Sundry Print Report

Well Name: POKER LAKE UNIT 13-24 Well Location: T24S / R29E / SEC 13 / County or Parish/State:

Type of Submission: Notice of Intent Type of Action: APD Change

Procedure Description: **Surface hole Change, First and Last Take Point Changes, Bottomhole Location Change, Drilling Plan Change, Casing/Cement Change XTO Permian Operating, LCC. requests permission to make the following changes to the original APD: No Additional Surface Disturbance SHL: fr/2354'FNL & 2444'FEL to 2459'FNL & 2340'FEL, NMNM05912 FTP: fr/2740'FNL & 2310'FEL to 1959'FNL & 2151'FEL, NMNM05912 LTP: fr/330'FSL & 2310'FEL to 2317'FSL & 2151'FEL, NMLC0696005A BHL: fr/200'FSL & 2310'FEL to 2367'FSL & 2151'FEL, Section 1-T24S-R29E NMLC0696005A Additionally, XTO Permian Operating, LLC. respectfully requests permission to upsize the surface, intermediate and production hole, casing, and cement based on the attached drilling program. Due to the upsize in these strings, the wellhead configuration has also changed based on the attached drilling program. Casing/Cement design per the attached drilling program. Attachments: C102 Drilling Program MBS Directional Plan

WELL LOCATION AND ACREAGE DEDICATION PLAT

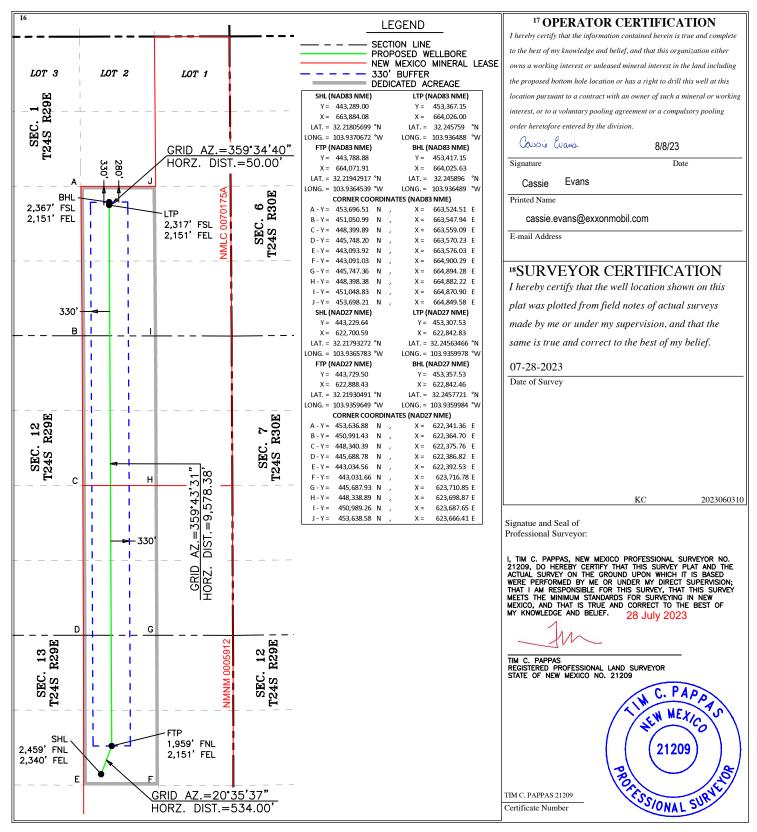
BHL: fr/200FSL & 2310FEL to 2367FSL & 2151FEL, Section 1-T24S-R29E NMLC0696005A

Additionally, XTO Permian Operating, LLC. respectfully requests permission to upsize the surface, intermediate and production hole, casing, and cement based on the attached drilling program. Due to the upsize in these strings, the wellhead configuration has also changed based on the attached drilling program.

UL or lot no.	Section	Township	Range	Lot Idn	Feet from the	North/South line	Feet from the	East/West line	County
J	1	24 S	29 E		2,367	SOUTH	2,151	EAST	EDDY
12 Dedicated Acres 13 Joint or Infill 14 Consolidation Code			Code 15 Or	der No.					
320
